Revised Analyses of Decommissioning for the Reference Pressurized Water Reactor Power Station

Effects of Current Regulatory and Other Considerations on the
Financial Assurance Requirements of the Decommissioning Rule
and on Estimates of Occupational Radiation Exposure

Final Report

Figure 3.1 Schedule of activities during the four periods of DECON

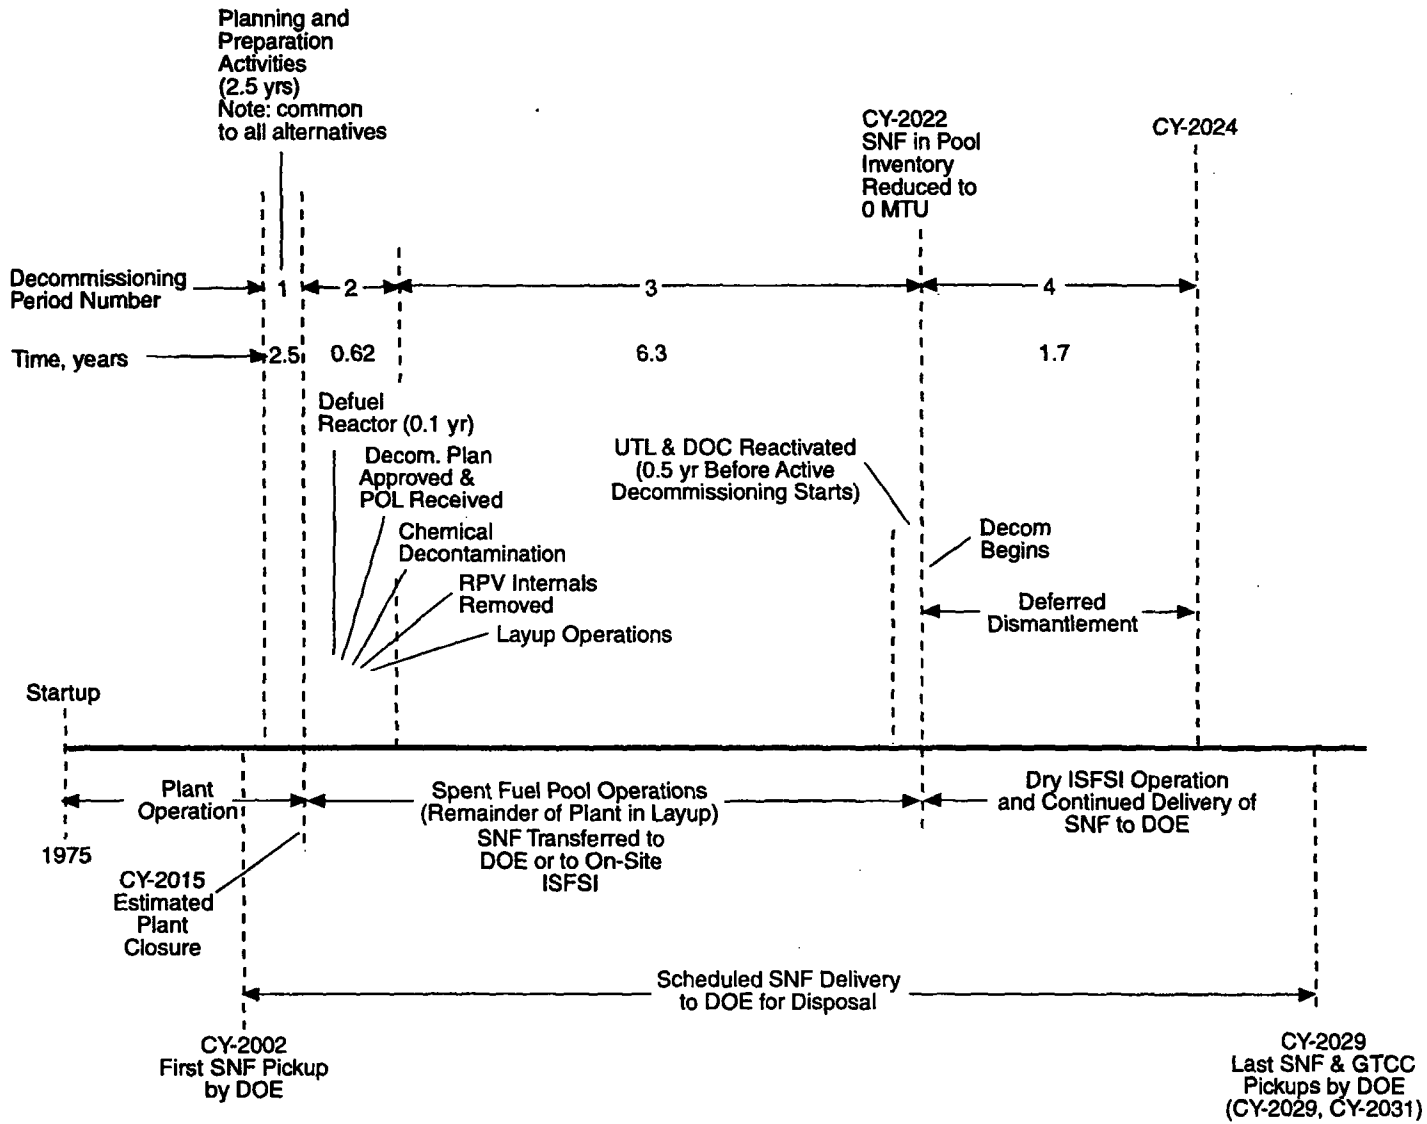
018-41 Comment: Figure 3.1: The On-Site ISFSI is a part of the decommissioning tasks. The ISFSI is provided to allow quick dismantling of the reactor portions of the facility. However, the ISFSI remains beyond the removal of the reactor facility. This ISFSI must also be decontaminated and dismantled, and is an unavoidable part of decommissioning this facility. This structure is developed solely as part of the decommissioning effort and cannot be charged to operations (as there is no operating plant). See general comment #1. Note that figure is not to scale.

Figure 3.2 Utility and DOC staff structure and staffing levels during pre-decommissioning: Period 1

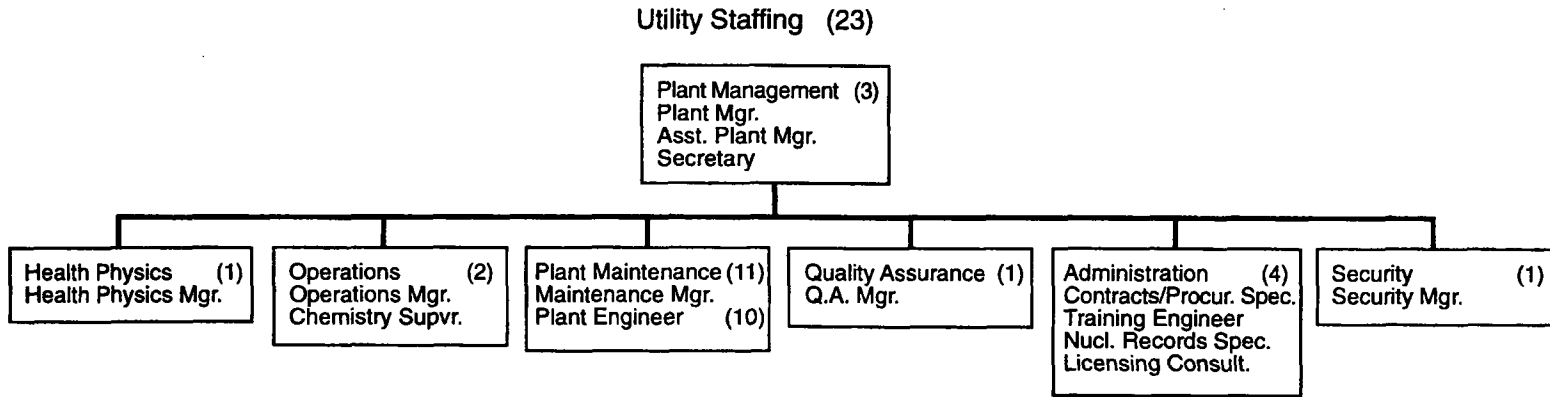
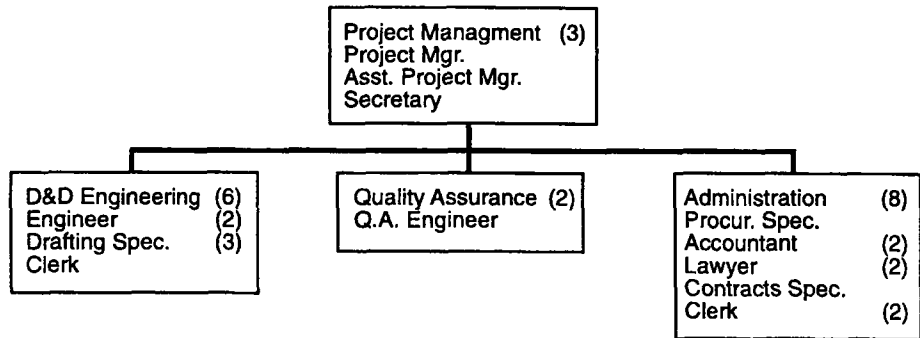
018-45 Comment: Figure 3.2: The utility staffing levels identified here (full-time) for Pre-Decommissioning do not match the decommissioning levels (part-time) identified in Table 3.2.

Figure 3.3 Schedule of activities during deactivation: Period 2

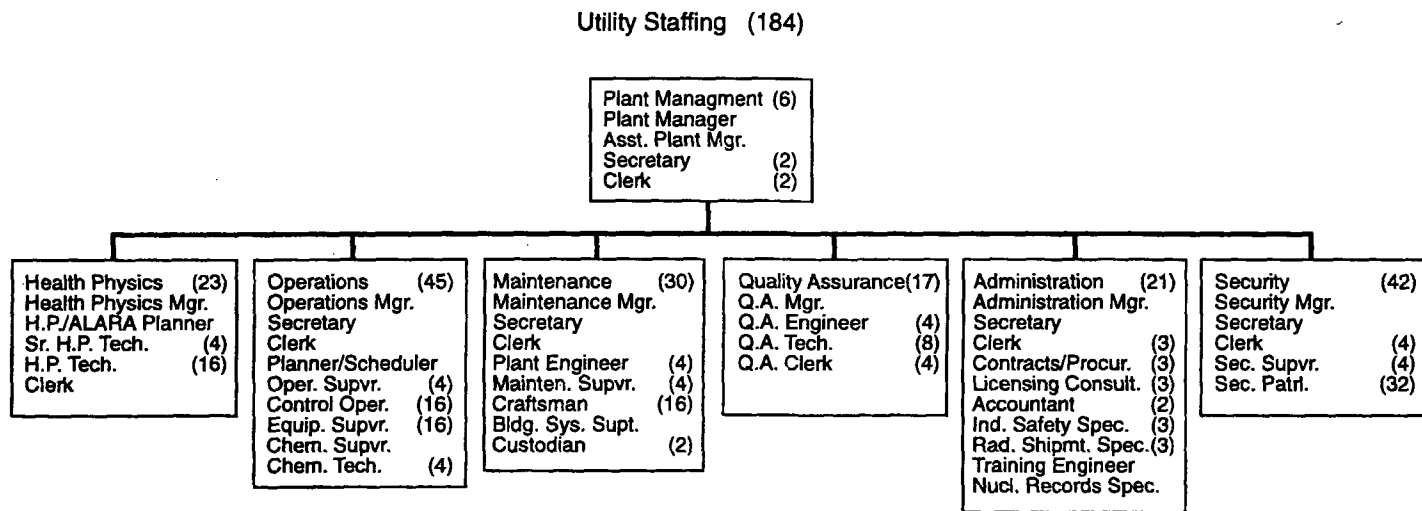
018-47 Comment: Figure 3.3: The third note ("Decon can start upon receipt of Decom. Plan approval") perpetuates the erroneous notion that decommissioning only means DECON. Decommissioning begins the moment the reactor is shut down for the final time. The existence of a plan, the decommissioning option used, and the source of funding are all irrelevant to the beginning of decommissioning from a Rate Commission viewpoint.

Response: No significant conflicts are expected. The schedule bars include the initial setup of the processes, then relatively short operating periods, followed by cleanup and removal of the processes. The schedule bars in Figure 3.3 have been modified to better illustrate these divisions of activities.

Response: The schedule and durations of the tasks represent the best judgement of the PNL analysts, and are based on detailed analyses of the individual tasks. Review of the schedule of activities given in Figure 3.3 shows that the periods of overlap are given to mobilization/demobilization, setup and testing, and cleanup and removal of the special systems and equipment used in the tasks. Without any knowledge of the circumstances at Yankee-Rowe, PNL cannot respond to the comment regarding the duration of cutting operations at Yankee-Rowe.

Figure 3.4 Utility staffing structure and levels following receipt of possession-only license: Period 2

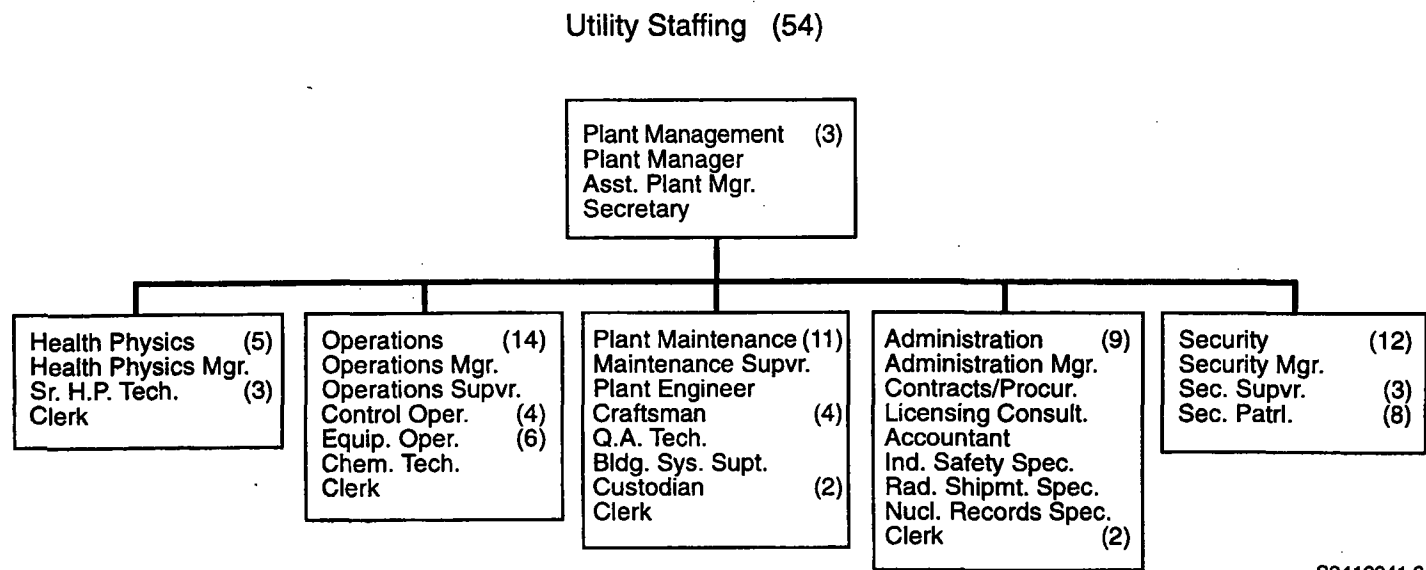
- 006-2 Comment: There are some inconsistencies in the staffing levels shown in the staff organizational structure charts. Figure 3.4 shows 23 persons in the Health Physics group; this should be 22, according to the breakdown. Figure 3.5 shows 13 in the Security group; this should be 12. Figure 3.6 shows 11 in the Utility Plant Operations group; this should be 12. That figure also shows 13 in the DOC D&D Engineering group; this should be 11.

Figure 3.6 Utility and DOC staff structures and staffing levels during dismantlement: Period 4

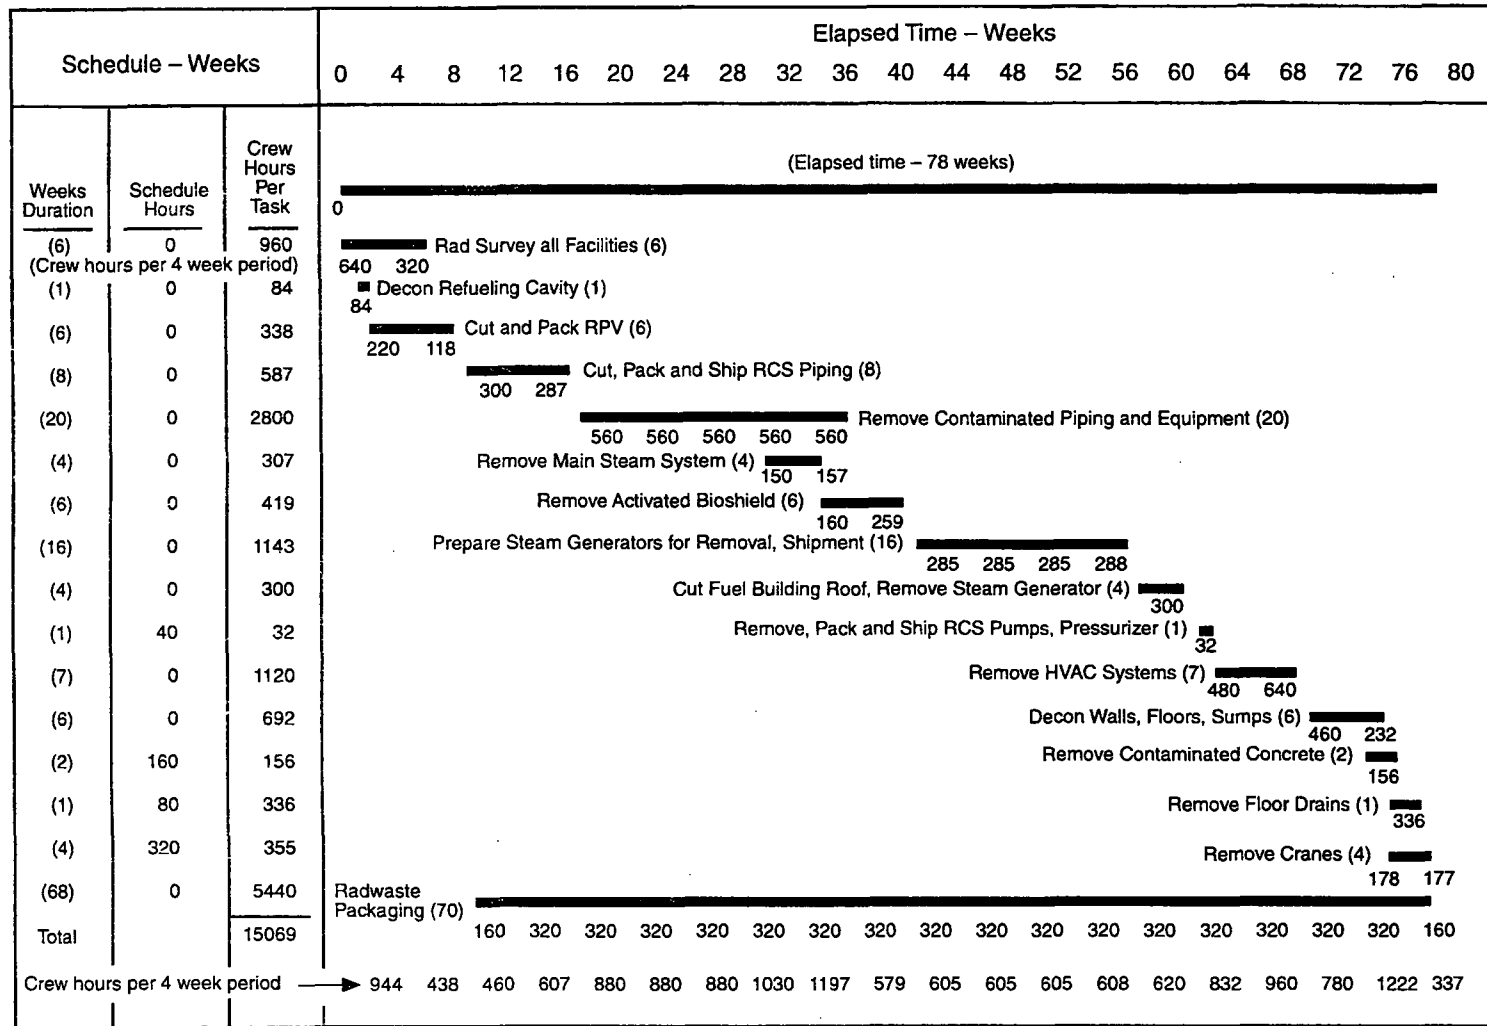
003-4 Comment: Page 3.12: PNL has assumed all work will be done on an 8-hour per day basis, two shifts per day. The utility and DOC staff shown in Figure 3.6 for Dismantlement does not indicate how many management personnel are dedicated for second shift operations. It is not reasonable to assume dismantling activities can be performed on second shift with no, or minimal second shift management.

018-51 Comment: Figure 3.6: The security staff identified (13 total) for Period 4 is not consistent with having spent fuel on site, with Period 2 (37 security staff), or with original studies (39 security staff). The movement of spent fuel to dry cask storage does not reduce site security staff requirements. This may be a result of arbitrarily assigning spent fuel security costs to "operations." See general comment #1.

- Response:** The numbers of staff in each classification are given in the staffing diagrams, Figures 3.2, 3.4, 3.5, and 3.6. The numbers of person-years for each classification in each period are given in Table 3.2.

Figure 3.7 Schedules and staffing for dismantlement activities in the Containment Building

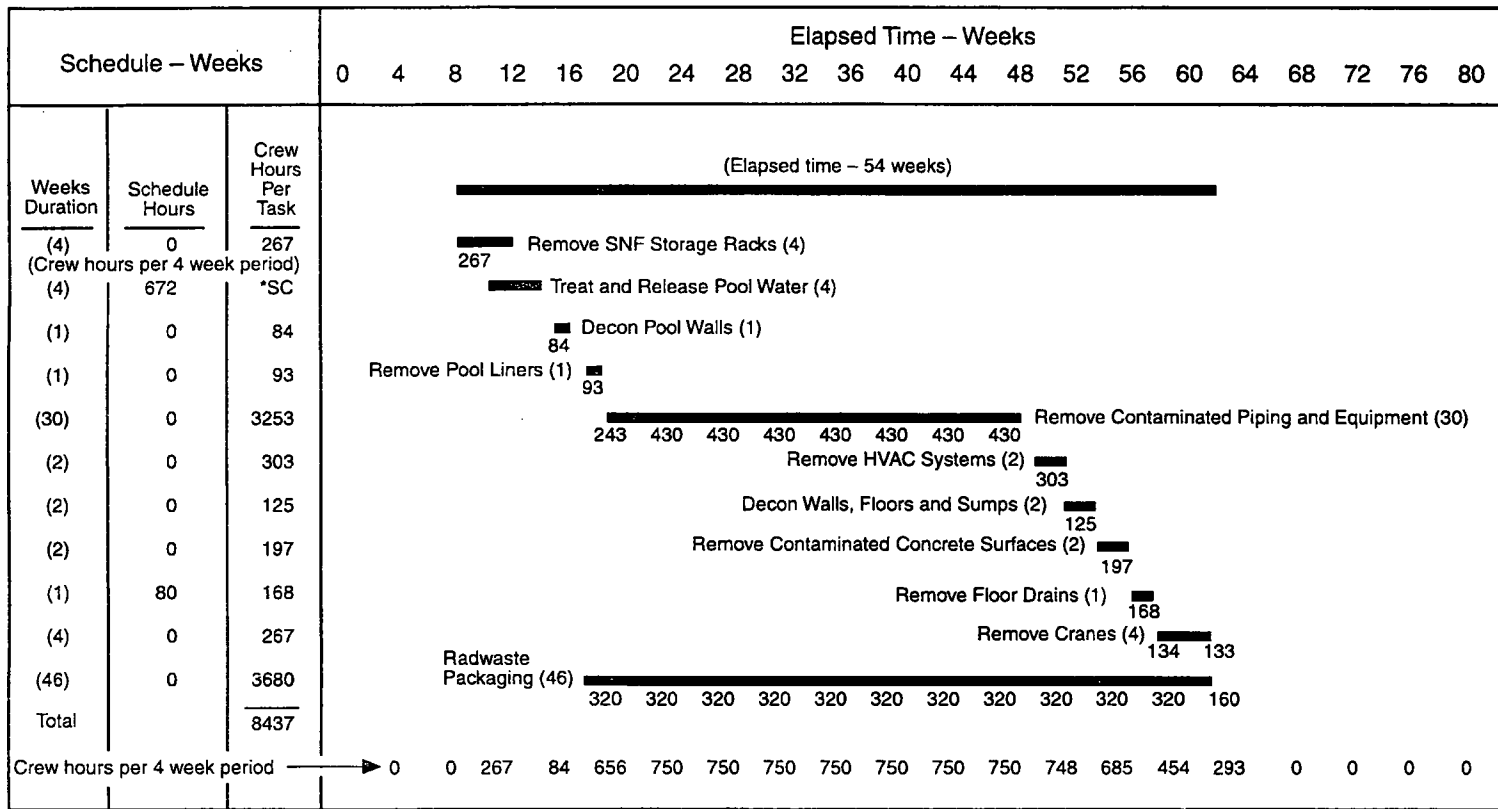
018-52 Comment: Figure 3.7: Apparent loading for Remove Floor Drains task should be 2, not 1.

018-66 Comment: Page 3.37, 2nd paragraph: Figure 3.7 indicates that the staff loading for bio shield removal is 6.5 people. Doses of 26 person-rem (13.4 pCi/gm or below) would therefore require additional staff to reduce dose rates to below NRC radiation dose limits. There is no indication that this has been done in this report.

Figure 3.8 Schedules and staffing for dismantlement activities in the Fuel Building

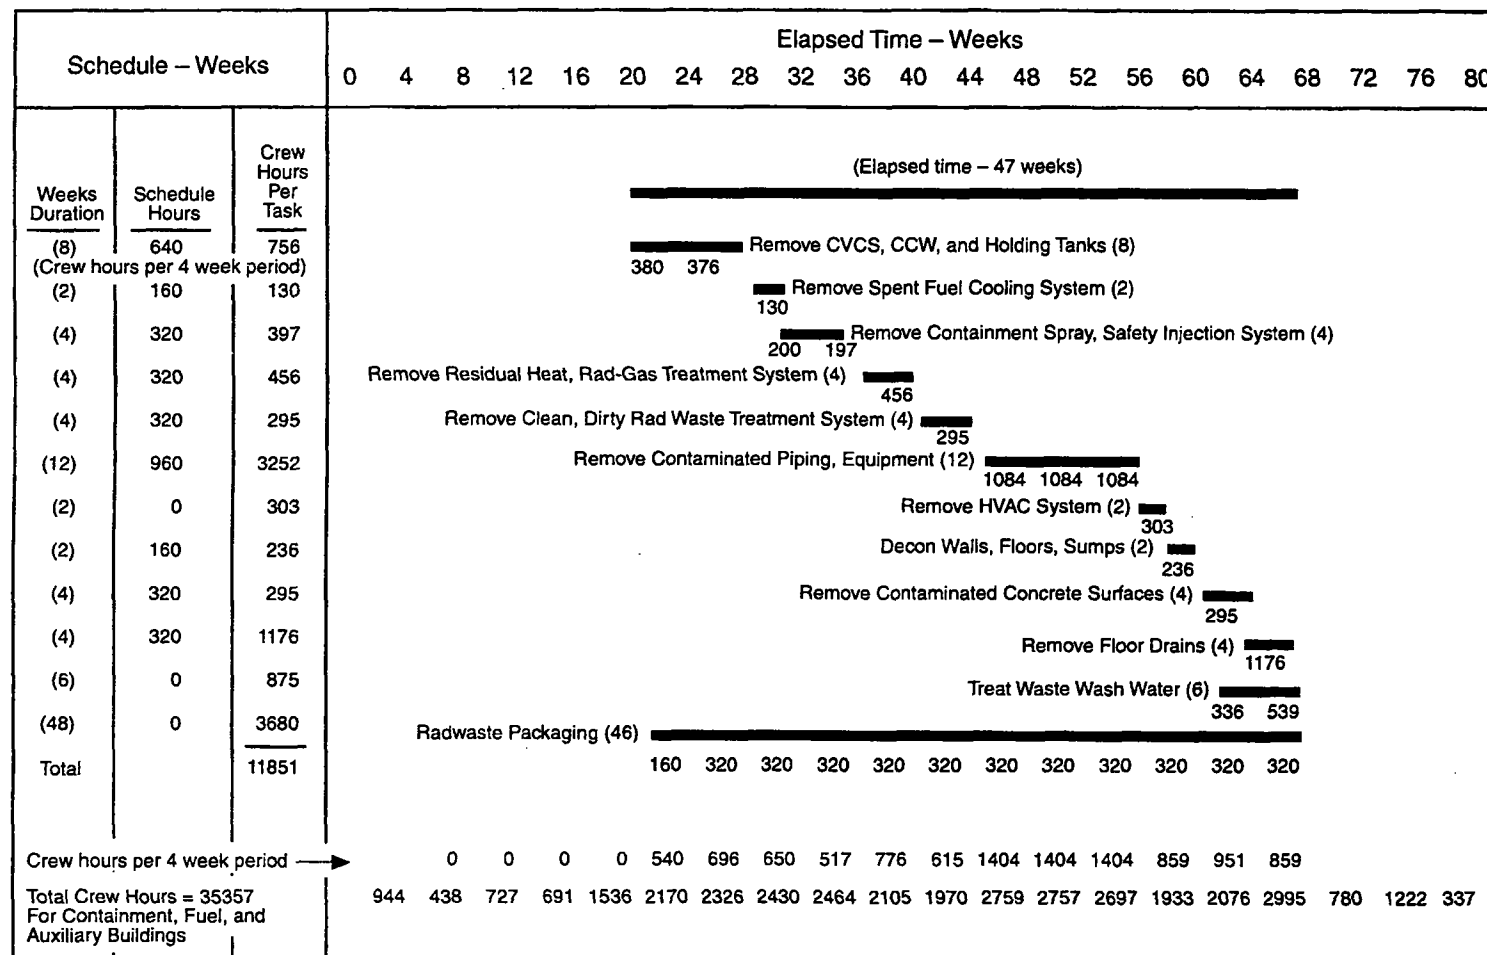
018-53 Comment: Figure 3.8: Elapsed time is 49 weeks, not 54 weeks (51 weeks if all tasks in line).

Figure C.2 Flow diagram for entering data into the CECP

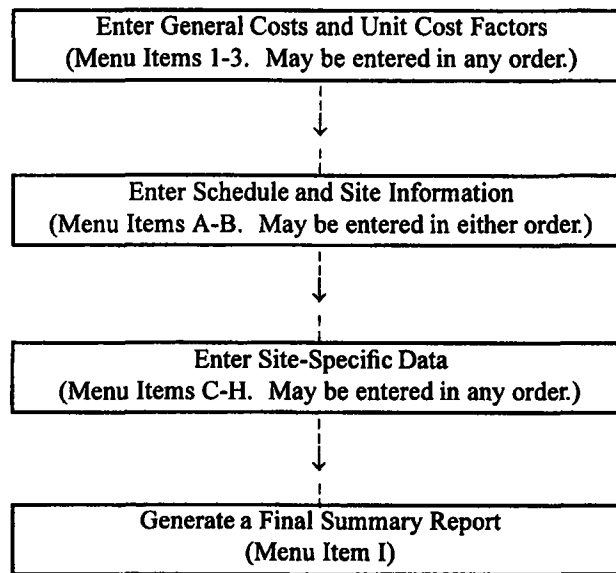
- 006-6 Comment: Section C restates verbatim much of NUREG/CR 6054. Consideration should be given to deleting this section from -5884; all discussion of the Cost Estimating Computer Program more appropriately belongs in 6054. If section C were deleted, the two volumes of NUREG/CR-5884 could be consolidated. (Furthermore, Figure 2.2 of 6054 is inconsistent with Figure C.2 of -5884 regarding sequence of data entry for menu items A, B, and C.)

Figure D.2 Present value costs for SNF storage operations

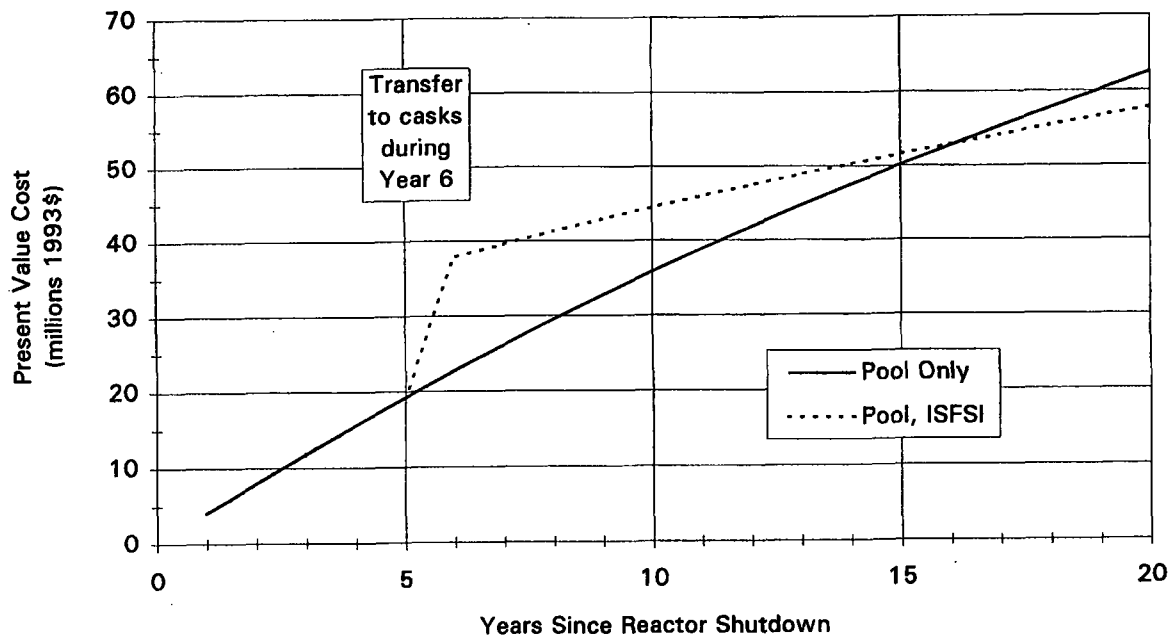
- Comment:** Figure D.2, which compares the present value cost of the pool option vs. the ISFSI option, does not present a valid comparison. First, the use of the 3% discount rate distorts the comparison. Second, the assumptions favored the pool option more than the ISFSI option. Third, and most importantly, the comparison does not address the impact on the overall decommissioning cost and schedule.

- Response:** The revised Figure D.2 illustrates the cumulative present values of the costs for SNF storage, using either the pool-only approach or the pool + ISFSI approach. The net result of the analysis would tend to favor pool-only storage for the first 16 years. If the inventory remains greater than zero beyond 16 years, the ISFSI approach becomes more cost-effective. The estimated annual cost for safe storage operations during the pool storage period are about \$936 K in constant 1993 dollars. Thus, the D&D costs would increase by that amount for every year that the pool remained in service.
